933 Main Street

**DESIGN/DEVELOPMENT REVIEW COMMISSION
DESIGN REVIEW DISTRICT
EVALUATION SHEET
Case # 3**

NATURE OF REQUEST: Informational Presentation

This proposal is for a new residential apartment building over parking on the parcel with the former Nickelodeon Theater and Immaculate Consumption. The existing building will remain. The project came before the Commission in August and was denied. The applicant has made changes based on the comments by Commissioners and is presenting to get feedback prior to submitting a formal application.

Parking Level
 Floor Plan
 Sheet No.
SD-6
 September 28, 2016

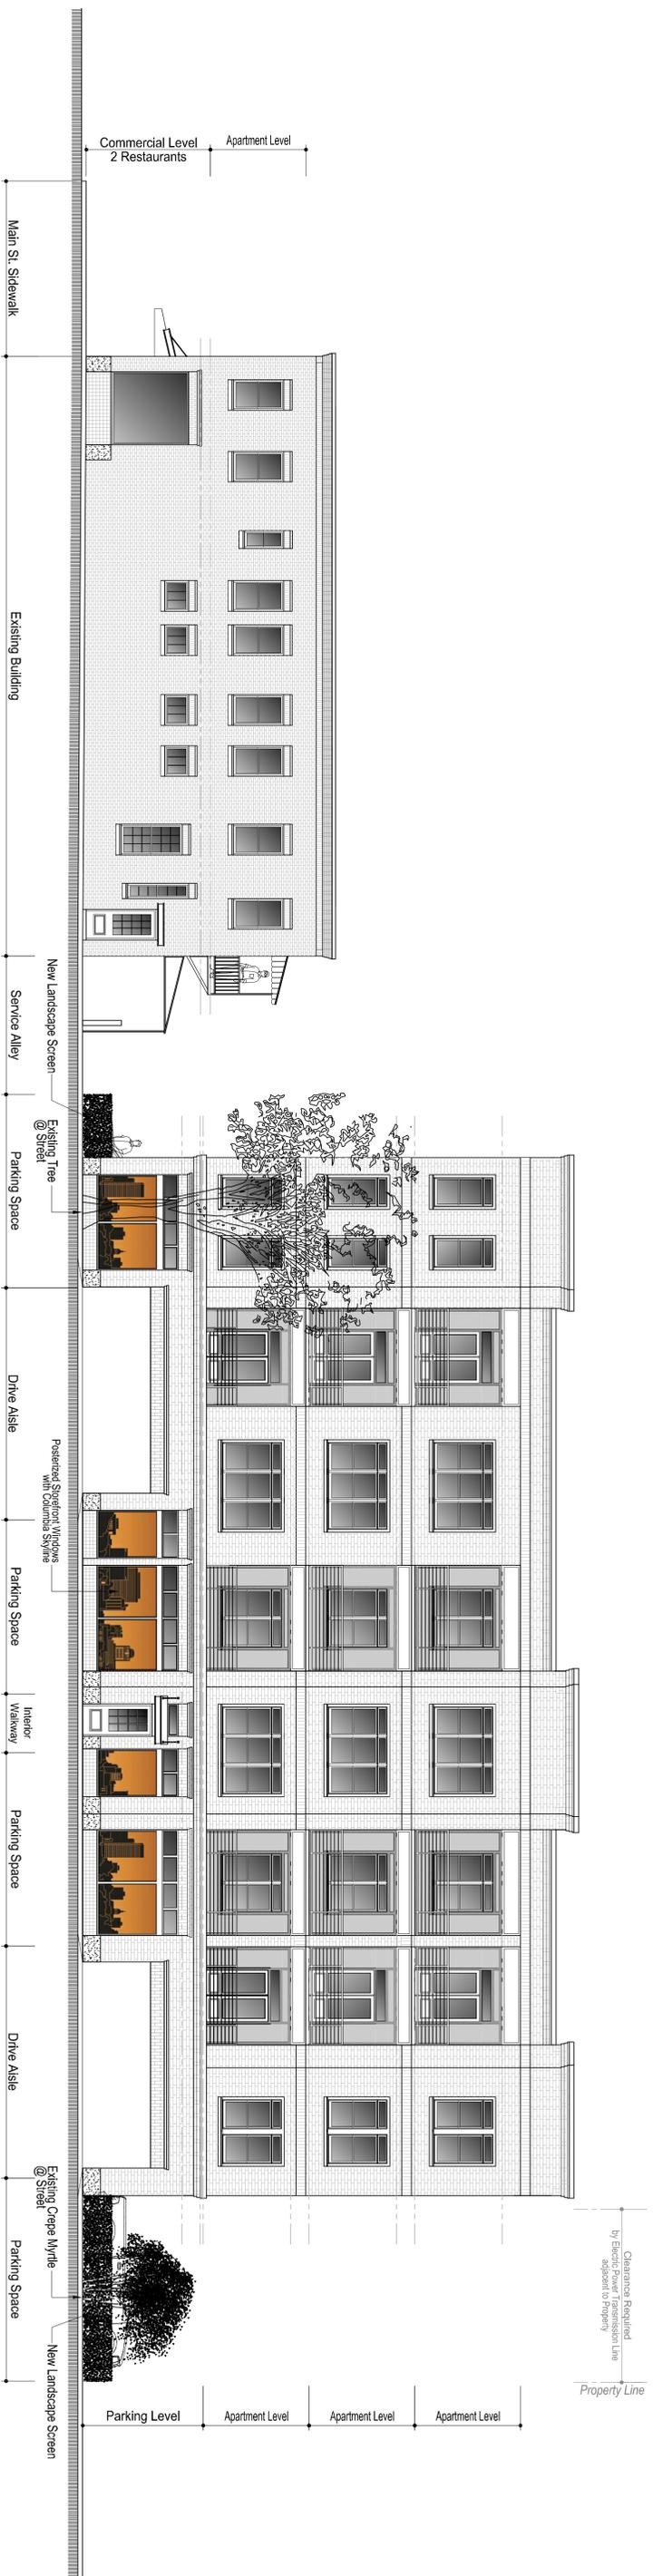
The piers are a critical part of making the first floor a believable base to the building. The applicant has rearranged the floor plans to align the piers with the base, as much as possible with the parking entrance configuration; however there are still piers that do not structurally align at the left driveway.

The parking, taking up the first level, is adjacent to the property line. The dimensions are so tight that there is no room for landscape screening.

West Elevation (Facing Power Row)

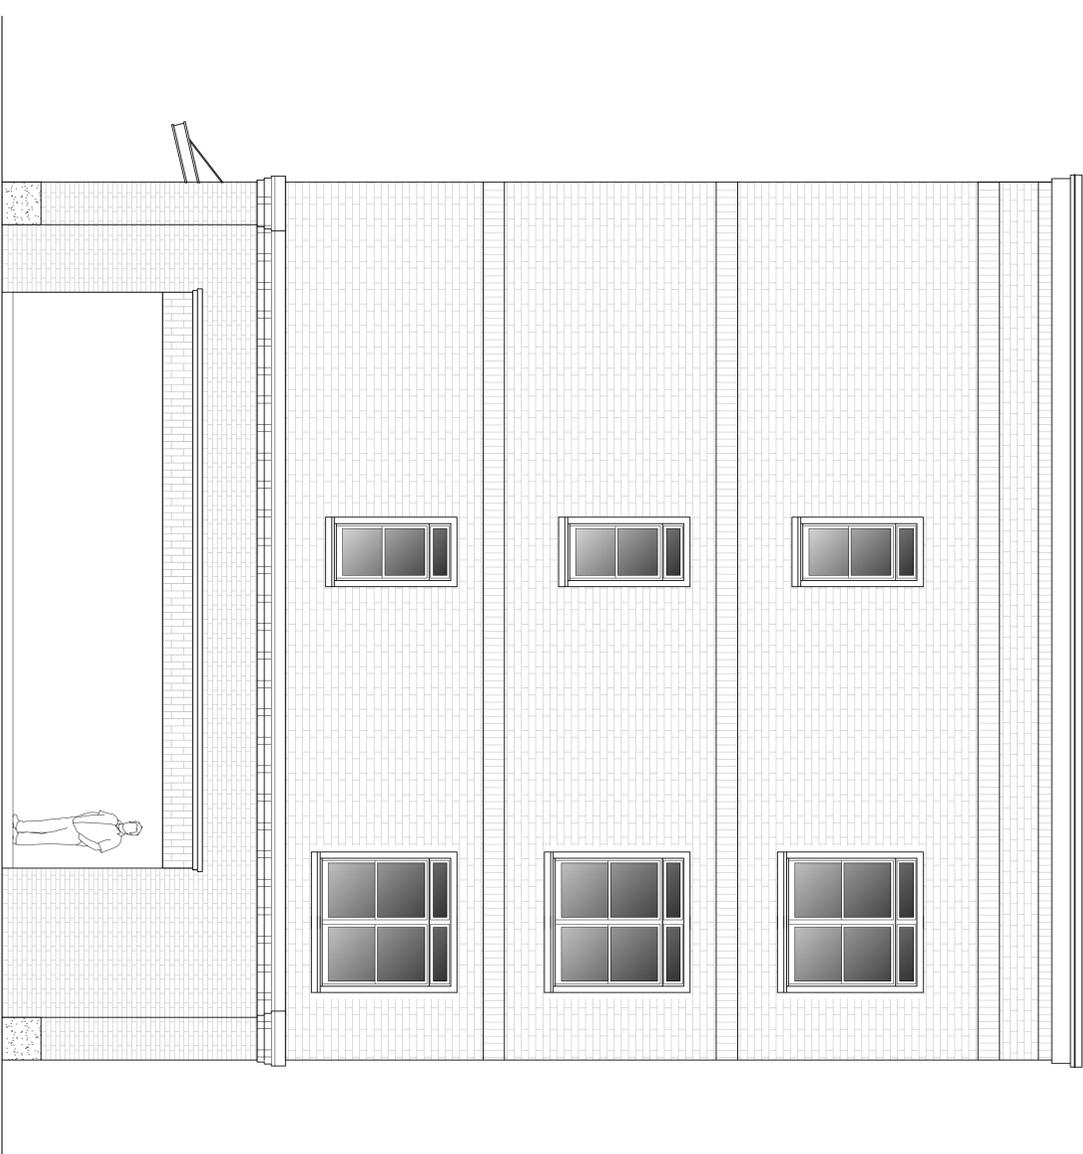
The west façade could benefit from additional fenestration. It was pointed out at the last presentation that this façade will be highly visible from Assembly Street and should be better articulated.
